Development Application **ACCESS REPORT**

Reference Number: 24352

Site Address: 190 Waterloo Rd, Greenacre, NSW

Executive Summary and Design Compliance Statement

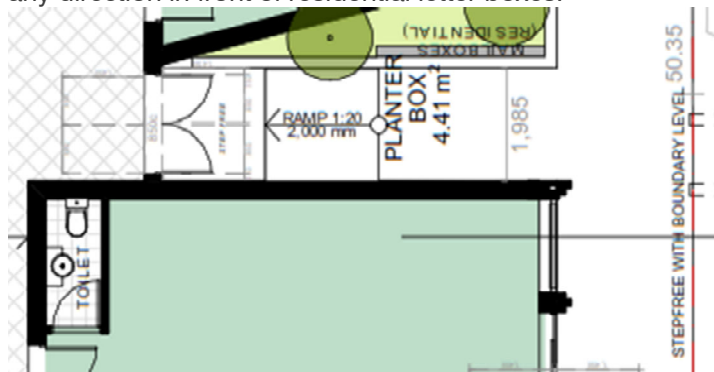
- Ensure provision of fully accessible step free entry from site boundary to common use main entry doors for both retail and residential component. Full details of entry pathways required to be shown on plans to verify compliance.

- 1540x2070mm clear space required to be provided on a hard paved area with max. grade of 1:40 in any direction in front of residential letter boxes.

- Ensure the length of this wall (shown with red arrow below) is less than 2M OR else 1540x2070mm clear space will be required to be provided at end of passageway on all levels with such design.

Updated plans are required to be provided to verify compliance at CC stage of works.
Details to be verified at CC stage of works.

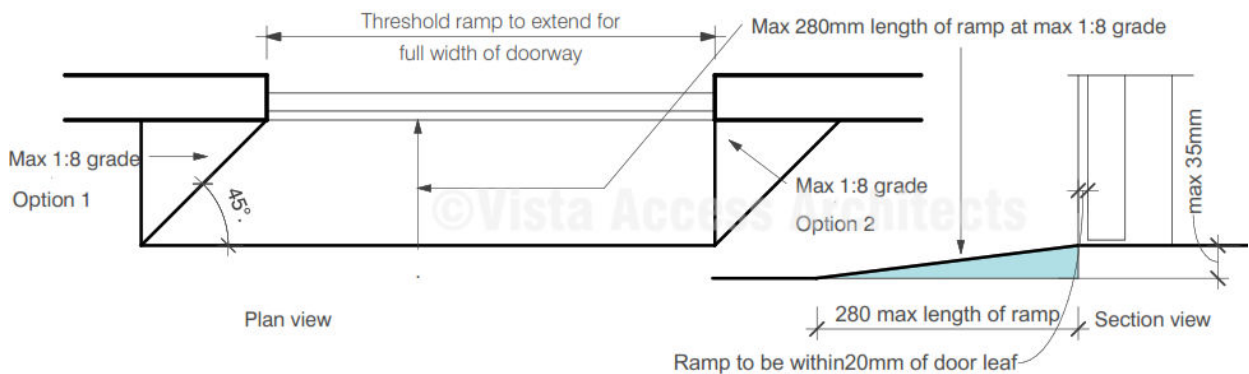
- Ensure ALL common use doorways provided in the development on ALL levels for both Retail and residential component are provided with min. 850mm clear door opening with clear door circulation spaces on both sides along with flush transition OR max. drop of 35mm with use of doorway threshold ramp.
- The door circulation templates provided for common use double doors and sliding doors in retail and residential component are incorrect and needs to be updated as per images shown below to achieve compliance at CC stage.

Updated plans are required to be provided to verify compliance at CC stage of works.

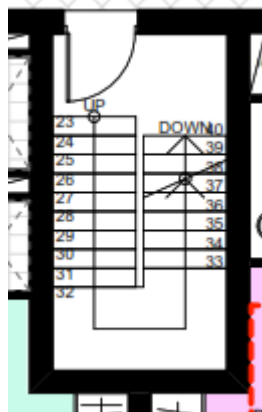
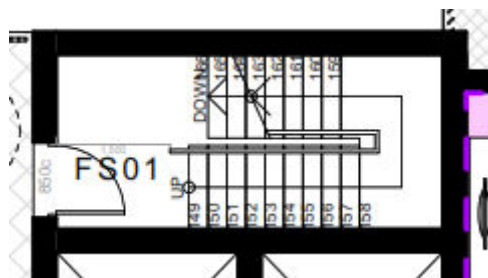
- Ensure provision of continuous handrail on one side with min. 1M clear width between handrail and wall on all levels for all fire stairs in the development.

- Ensure provision of min. 300mm handrail extension at top of each fire stairs.

Updated plans are required to be provided to verify compliance at CC stage of works.
Details to be verified at CC stage of works.

[Image description: Plan of Basement 01 above shows the provision of Accessible parking spaces]

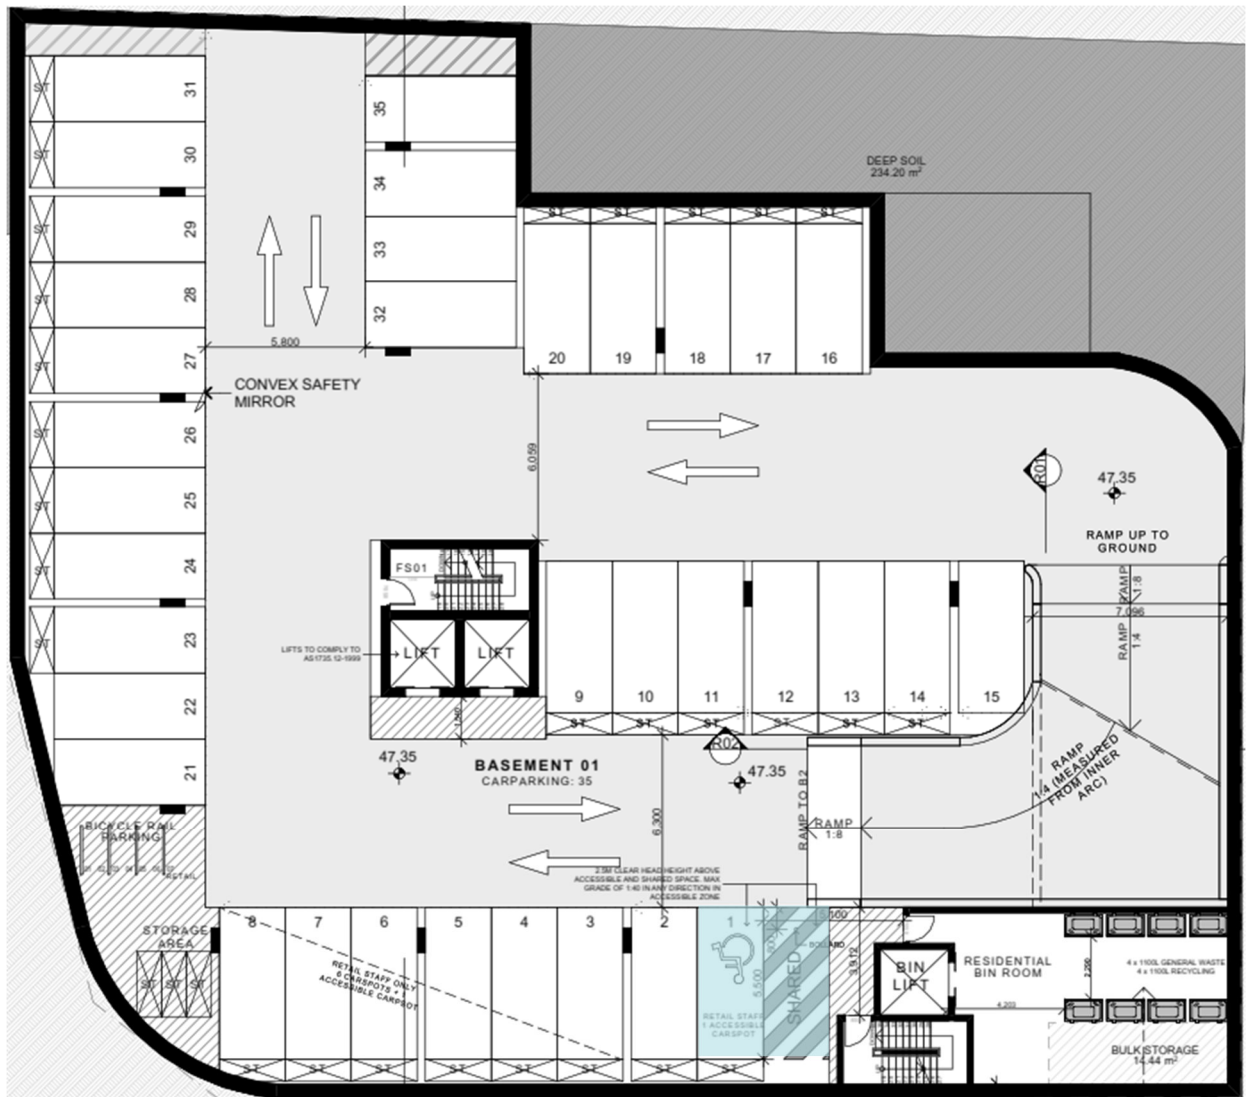
- 1 Accessible car parking space per 50 carparking spaces (up to 1000 spaces) and additional 1 Accessible car parking space per additional 100 spaces provided

Complies

TYPICAL LAYOUT SILVER LEVEL
Typical units - 302, 402, 502, 602

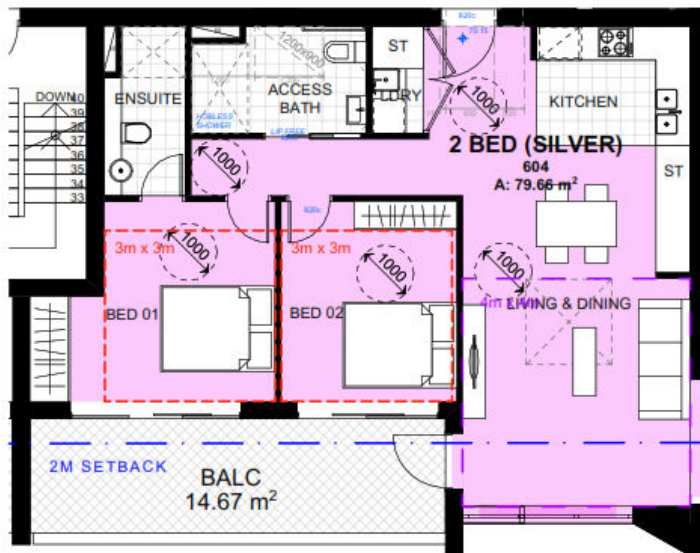
NOTE- The typical unit numbers listed in detailed plans for silver units does not match with general floor plan unit numbers. Ensure same unit numbers are replicated in detailed plans as shown on general floor plans at CC stage of works

Notes for typical units 301, 401, 501, 601, 302, 402, 502, 602:

- Ensure all doorways in all above silver livable units are provided as min. 820mm clear door opening.
- Ensure provision of min. 1M clear width of all common use passageways when measured between skirtings.
- Ensure provision of min. 1200x1200mm clear space external to Main Entry doorway of all silver units.
- Ensure provision of flush transition to wet areas of all silver units. One way of achieving this is to recess the floor slab.

Typical units – 304, 404, 504, 604

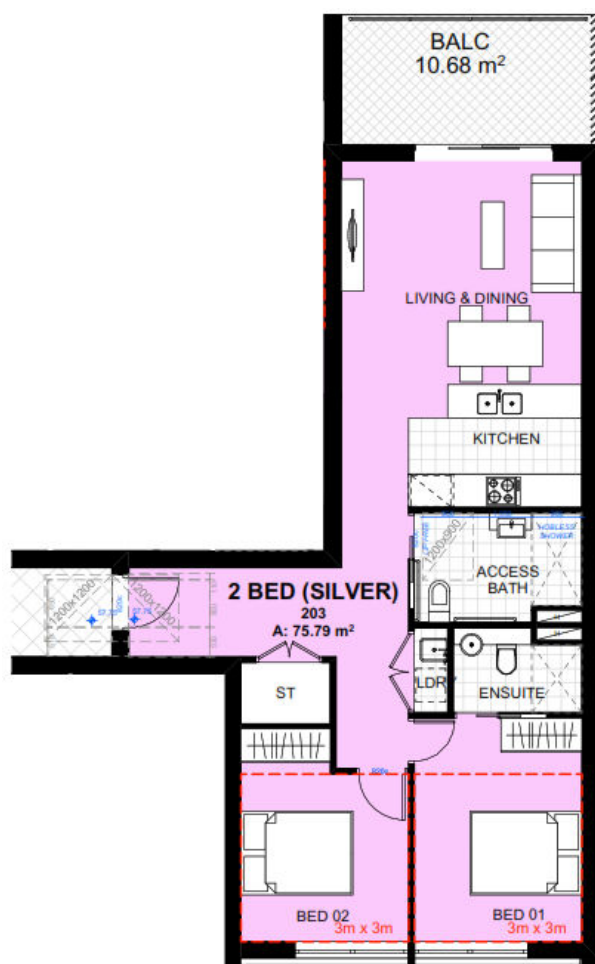
Notes for typical units 304, 404, 504, 604:

- Ensure all doorways in all above silver livable units are provided as min. 820mm clear door opening.
- Ensure provision of min. 1200x1200mm clear space external to Main Entry doorway of all silver units.

- Update main bathroom design to achieve compliance. Refer to image shown below and update plans at CC stage of works.

Updated plans are required to be provided to verify compliance at CC stage of works.

Typical units - 210, 310, 410, 510, 610

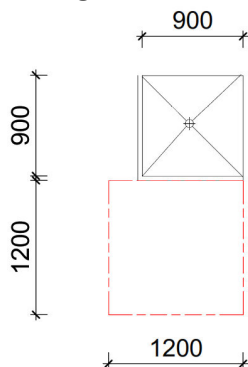
NOTE- The typical unit numbers listed in detailed plans for gold units does not match with general floor plan unit numbers. Ensure same unit numbers are replicated in detailed plans as shown on general floor plans.

Notes for typical gold units 210, 310, 410, 510, 610:

- Ensure all doorways in all above gold livable units are provided as min. 850mm clear door opening.

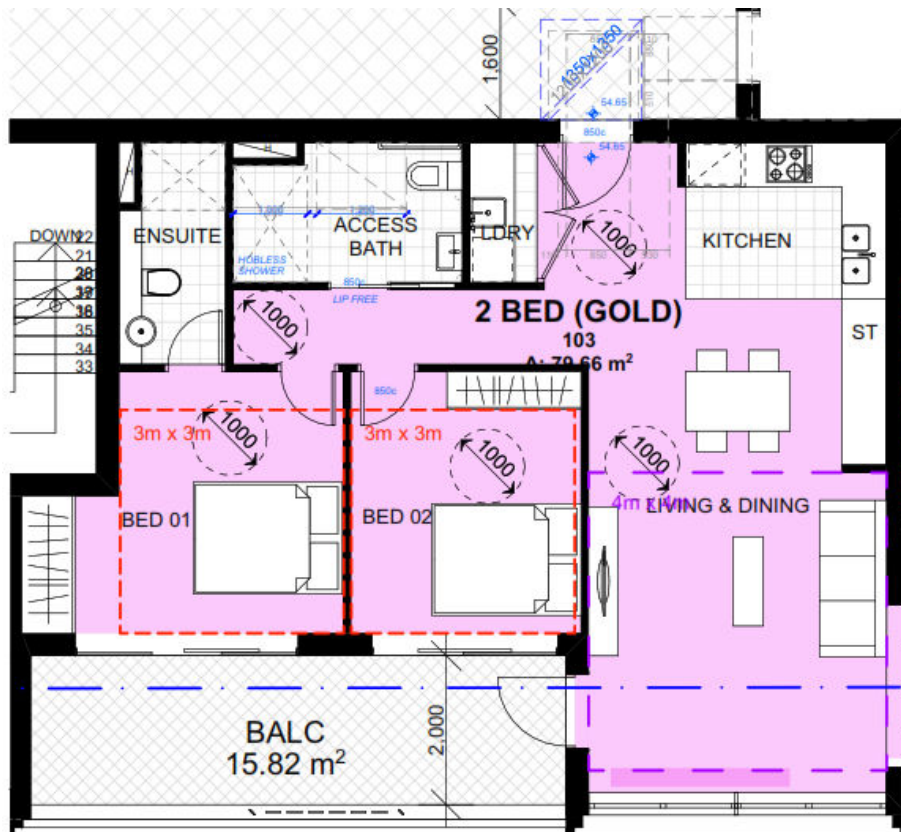
Notes for typical gold units 103, 303, 403, 503, 603:

- Ensure all doorways in all above gold livable units are provided as min. 850mm clear door opening.
- Ensure provision of min. 1.2M clear width of all common use passageways when measured between skirtings.
- Hobless shower area in gold unit required to be provided with dimensions of at least 900mm (width) x 900mm (length) (internal space clear of any shower screen fixtures) and dimensions of at least 1200mm(width) x1200mm (length) forward of the shower recess is required to achieve compliance. Refer to image.

Bathroom design revision required in this typical units to achieve compliance.
Updated plans required to be provided at CC stage of works to verify compliance.
